ACCESS ASSESSMENT ADDENDUM

**CHANGE OF USE OF LAND
TO TRAVELLER SITE WITH 4 PITCHES
AT
STRYT Y BYDDEN
NEW BROUGHTON WREXHAM**

SITE ADDRESS	Stryt Y Bydden New Broughton Wrexham LL11 6SN
REPORT TITLE	Access Assessment Addendum
JOB NUMBER	963-24
PREPARED BY	JRS

CONSTRUCTION PROPOSALS DRAWING 963-24-20

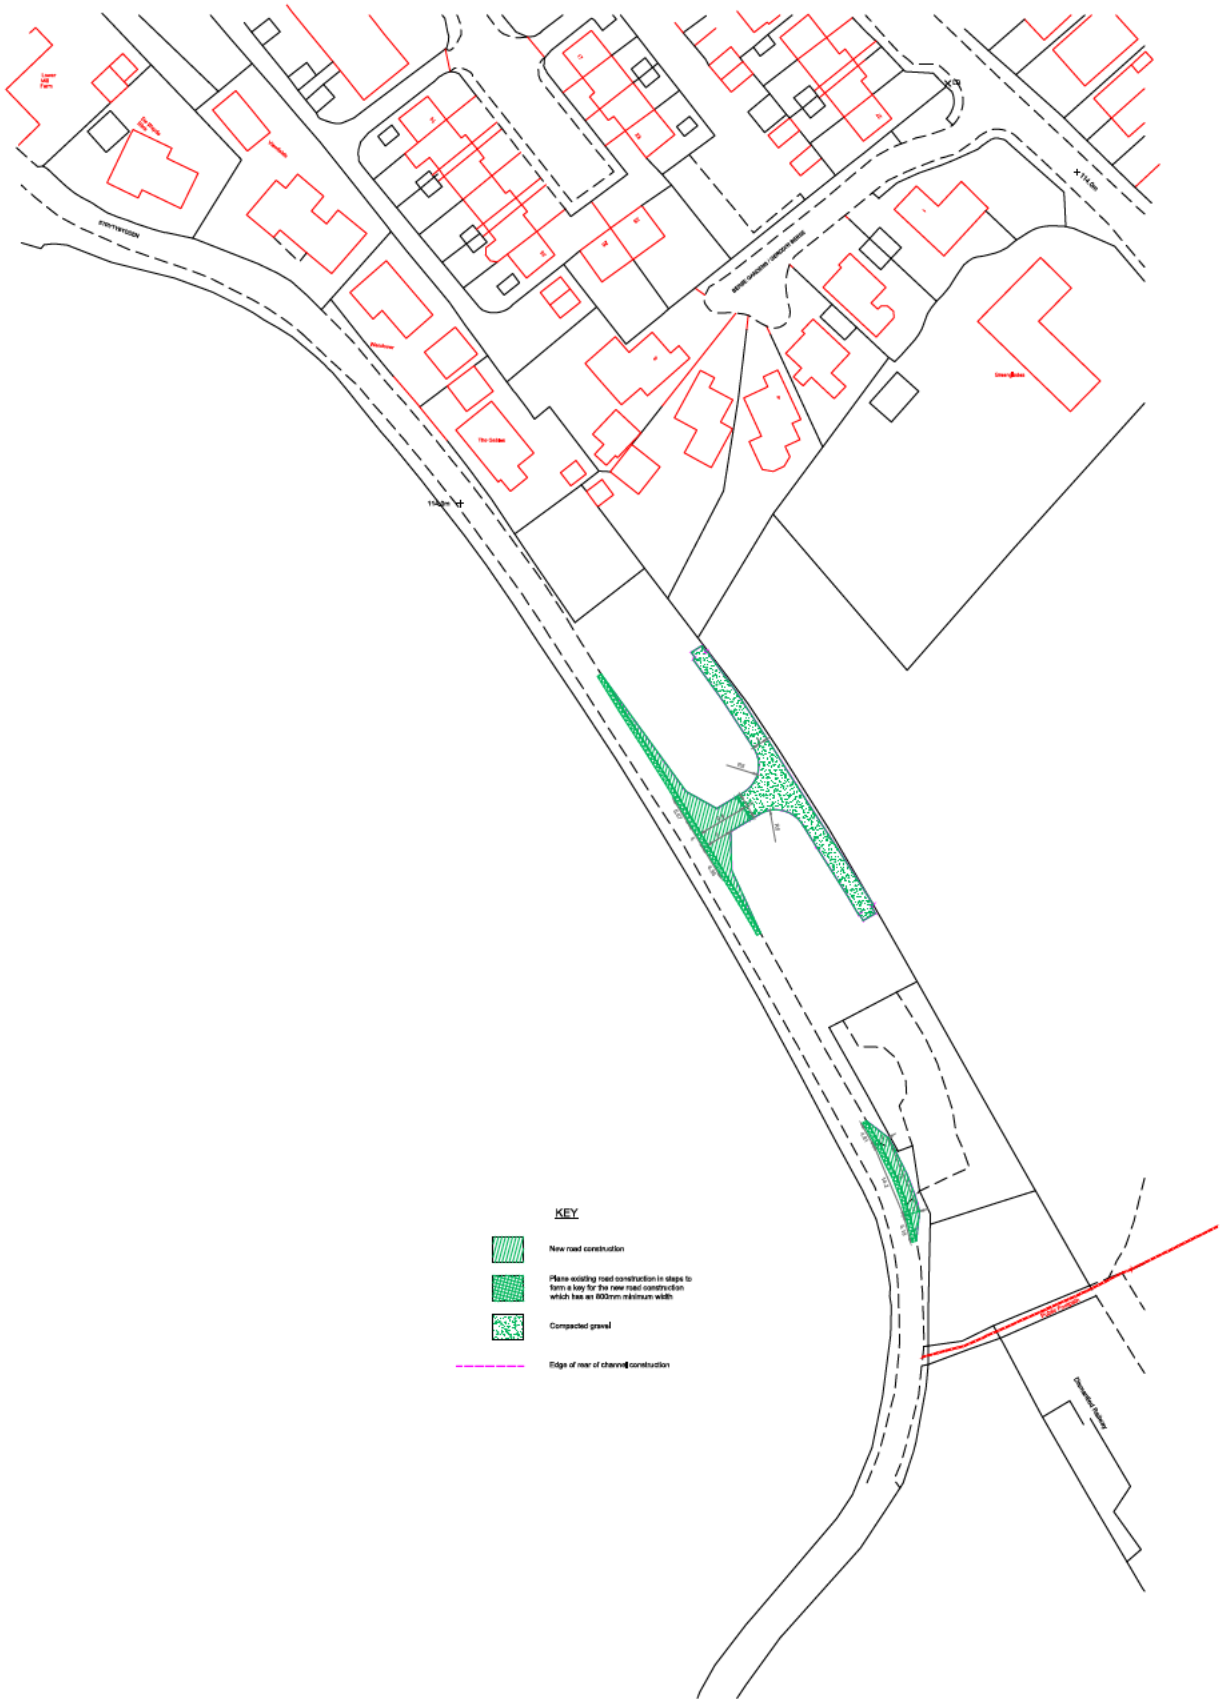
- 2.3. *There are no dimensions shown on the proposed site entrance drawing prior to the LHA being able to approve or otherwise. Swept path analysis should also be provided to show that an 11.5m long refuse wagon and average family car could pass at the entrance.*

- 2.6. *If the entrance widening is proposed as a passing place, Increased surfaced highway Construction to highways standards Should be provided along The length and width of the visibility splays. This should be clarified and noted on updated drawings.*

The dimension for the proposed site entrance are shown on Construction Proposals drawing 963-24-20 in Appendix 6.

2.6.1. The entrance proposals are shown on Construction Proposals drawing 963-24-20 in Appendix 6.
